State of New Mexico
Energy, Minerals and Natural Resources

OIL CONSERVATION DIVISION
1220 South St. Francis Dr.
Santa Fe, NM 87505

WELL API NO. 30-015-34575
5. Indicate Type of Lease STATE <input checked="" type="checkbox"/> FEE <input type="checkbox"/>
6. State Oil & Gas Lease No.
7. Lease Name or Unit Agreement Name Spud 16 State
8. Well Number 6
9. OGRID Number 6137
10. Pool name or Wildcat Laguna Salado; Atoka (gas)

SUNDRY NOTICES AND REPORTS ON WELLS
(DO NOT USE THIS FORM FOR PROPOSALS TO DRILL OR TO DEEPEN OR PLUG BACK TO A DIFFERENT RESERVOIR. USE "APPLICATION FOR PERMIT" (FORM C-101) FOR SUCH PROPOSALS.)
1. Type of Well: Oil Well ☐ Gas Well ☒ Other: **NM OIL CONSERVATION ARTESIA DISTRICT**

PROPOSED WELLBORE

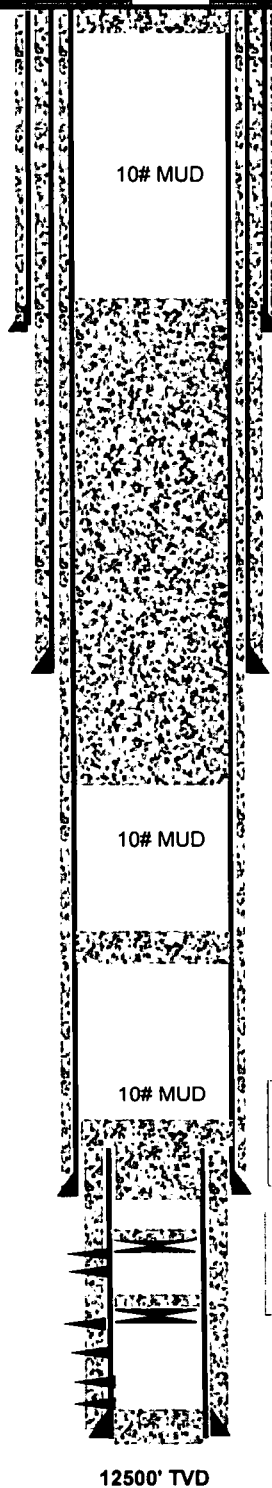
- Notify OCD 24 hrs. prior to any work done. **R-111-P**
1. MIRU P&A Unit.
 2. Set CIBP @ 11100'. **H cmt on 3 + 4**
 3. Spot 20 sx CI C 11000'-11100'. - WOC + Tag
 4. Spot 50 sx CI C 9900'-10500'. WOC & Tag (Liner top 10169', T. Wolfcamp 10070)
 5. Spot 100 sx CI C 6500'-7000'. (T. Bone Spring 6687')
 6. Spot 700 sx CI C 300-3600. WOC and Tag. (Shoes 2978', 374', T Bell Canyon 3035', T Salt 378, B Salt 2775 R-111P)
 7. Spot 10 sx CI C 3'-35'. 100'
 8. Cut WH off 3' BGL, Set dry hole marker.

must be plugged by 10-18-19

Proposed:
 1. Spot 10 sx CI C 3'-33'.
 2. Cut WH off 3' BGL, Set dry hole marker.

Proposed:
 Spot 700 sx CI C 300-3600. WOC and Tag.
 (Shoes 2978', 374', T Bell Canyon 3035', T Salt 378, B Salt 2775 R-111P)

Proposed:
 Spot 100 sx CI C 6500-7000.
 (T. Bone Spring 6687')

Proposed:
 1. Spot 50 sx CI C cmt 9900'-10500'. WOC & Tag
 (Liner top 10169', T. Wolfcamp 10070)

Proposed:
 1. Set CIBP @ 11100'.
 2. Spot 20 sx CI C cmt 11000'-11100'.
